PRODUCT / PROCESS CHANGE NOTIFICATION

| 1.2 PCN No. | ADG/24/14531 |
| 1.3 Title of PCN | L9026 (UR5V): Activation of Additional Assembly Plant (TFME) |
| 1.4 Product Category | L9026-YO-TR |

MISSION PROFILE

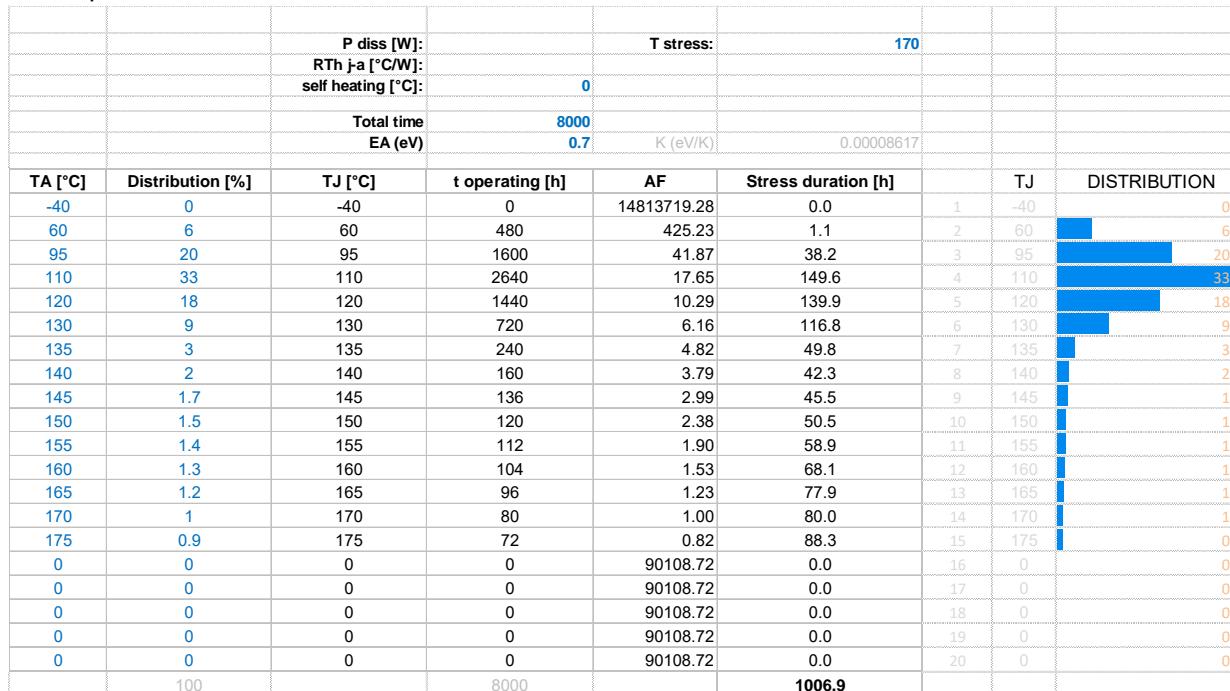
- a) Operating time: 8000h
- b) Activation Energy: 0.7eV
- c) Junction temperature spectrum:

Stress temperature: $T_{\text{stress}} = 170/175^{\circ}\text{C} \rightarrow \text{HTOL Duration} = 1007\text{h}/821\text{h} \rightarrow 1000\text{h}$

Pulses: 18M pulses
